The Secretary
NSW Planning, Industry & Environment

10 December 2019

I refer to the Department's below email of 8 November 2019 regarding State Significant Development SSD-9477 at O'Keefe Drive, Oran Park (Lot 1001 DP 1234527) for 'New Catherine Field Primary School. The development of a new public primary school to accommodate up to 1,000 students including 44 classrooms, a hall, an administration/staff centre, library resource centre, amenities and storage, staff car parking and site services'. Submissions need to be made to the Department by 11 December 2019.

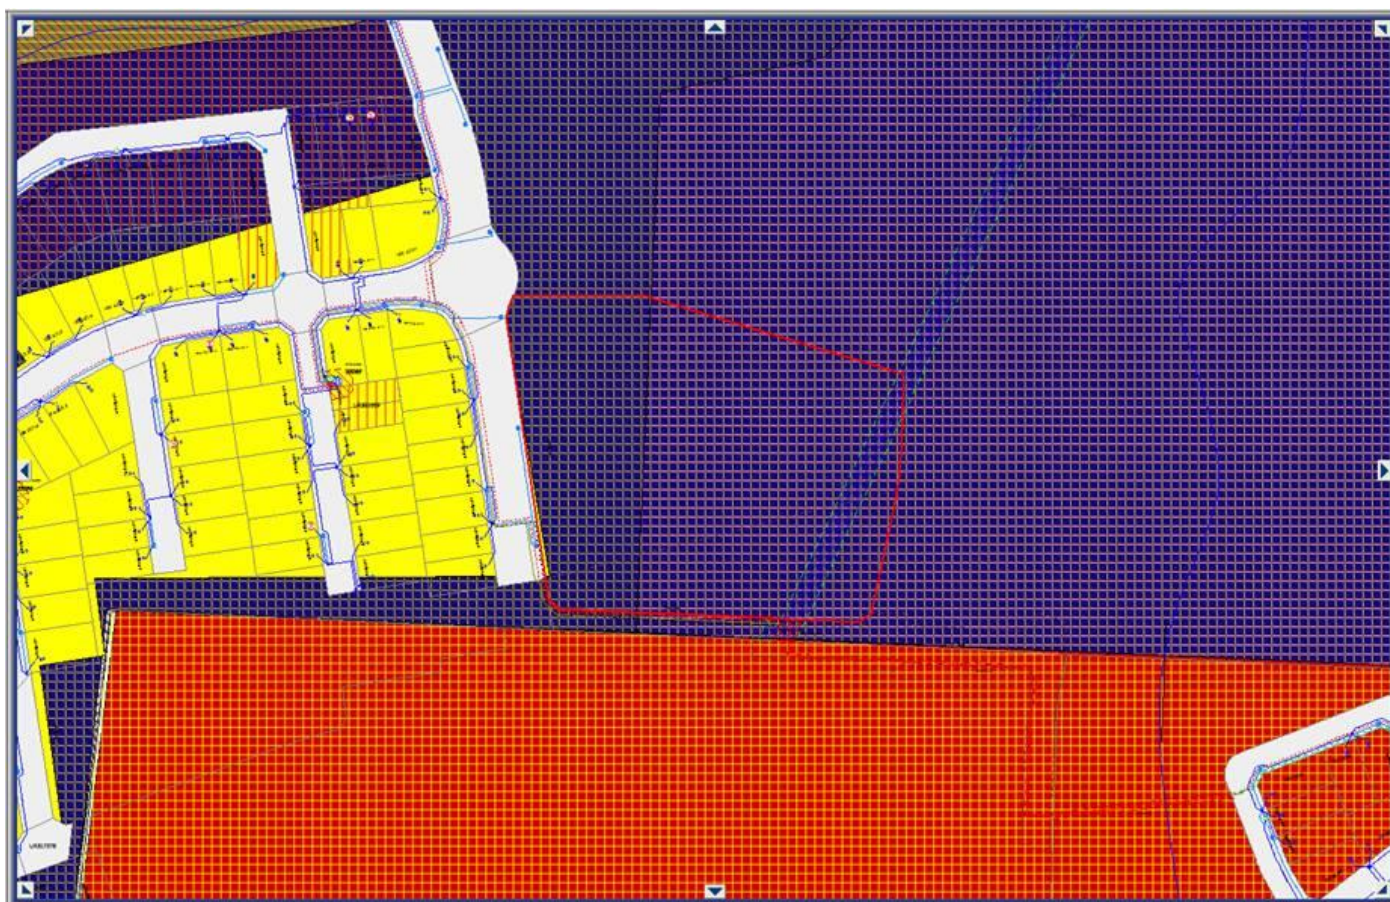
The following site plan from Endeavour Energy's G/Net master facility model shows the site is covered by parts of various 'Work Polygons' (depicted by the coloured highlighting and/or hatching of the lot) indicating enquiries and applications for proposed contestable works projects with Endeavour Energy's Network Connections Branch for electricity supply to the development for urban residential subdivision (Endeavour Energy's reference URS and ARP numbers). As such, Endeavour Energy's Network Connections Branch are managing the conditions of supply with the proponent and their Accredited Service Provider (ASP). However there is no specific 'Work Polygon' for the school site and the applicant will need to contact Endeavour Energy's Network Connections

- Includes any contestable works projects that are outside of the existing approved / certified works.
- Results in an electricity load that is outside of the existing Supply / Connection Offer requiring the incorporation of the additional load for consideration. This is due to load being based on a desktop assessment using an After Diversity Maximum Demand (ADMD) where demand is aggregated over a large number of customers providing an ADMD for the site / per lot. Depending on the actual development proposed for the site, the ADMD provided may not be sufficient.

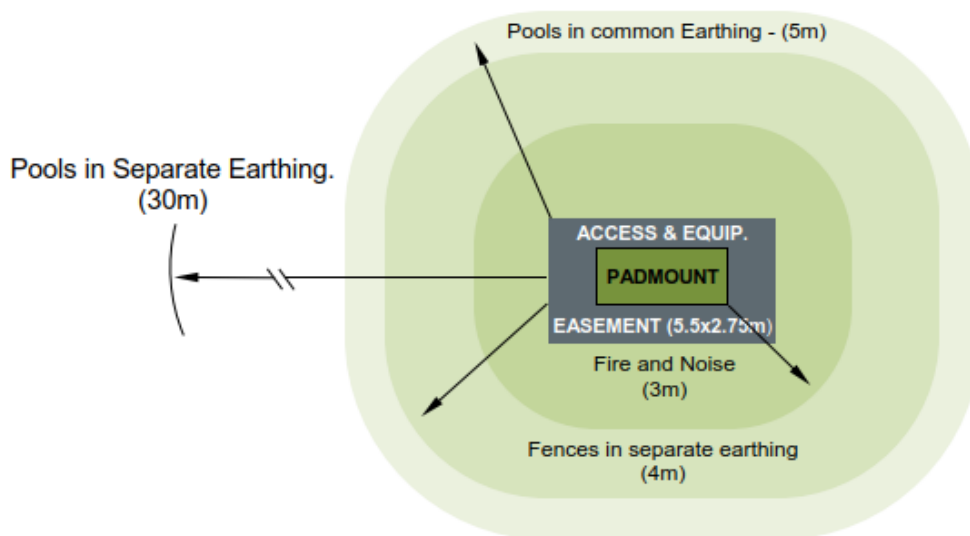
As shown in the following extract of the Proposed Architectural Plans provision has been made for a padmount substation to the O'Keefe Drive frontage of the site.

As indicated in the Infrastructure Management Plan, a padmount substation will be required to facilitate the construction of the new school. There are currently no 11 kV high voltage underground feeders in the locality of the padmount substation shown in the Proposed Architectural Plans and these would need to be extended to the proposed substation site to provide supply.

From Endeavour Energy's perspective the fact that provision is being made for the substation is a positive. Endeavour Energy's general requirements is for a padmount substation to be at ground level and have direct access from a public street (unless provided with a suitable easement for right of access). It must be protected (including any associated cabling) by an easement and associated restrictions benefiting and gifted to Endeavour Energy as outlined in the attached copy of Endeavour Energy's Mains Design Instruction MDI 0044 'Easements and Property Tenure Rights'.

Generally it is the Level 3 Accredited Service Provider's (ASP) responsibility (engaged by the developer) to make sure that the substation location and design complies with Endeavour Energy's standards the suitability of access, safety clearances, fire ratings, flooding etc. As a condition of the Development Application consent the Department should request the submission of documentary evidence from Endeavour Energy confirming that satisfactory arrangements have been made for the connection of electricity and the design requirements for the substation, prior to the release of the Construction Certificate / commencement of works.

Figure 45 - Minimum FRL clearances for components

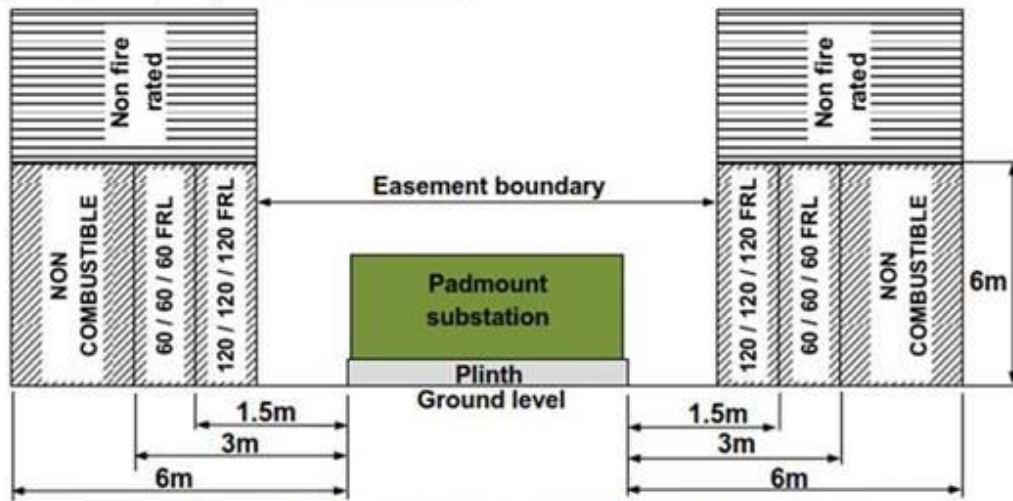
Padmount substations require separation from neighbouring areas and buildings that are subject to fire risk. Separation may be by means of adequate clearances or building components having minimum fire resistance level (FRL) as set out in Figure 45.

Fire ratings shall be achieved by static means (that is, walls or distance) rather than active system (that is, deluge showers and the like).
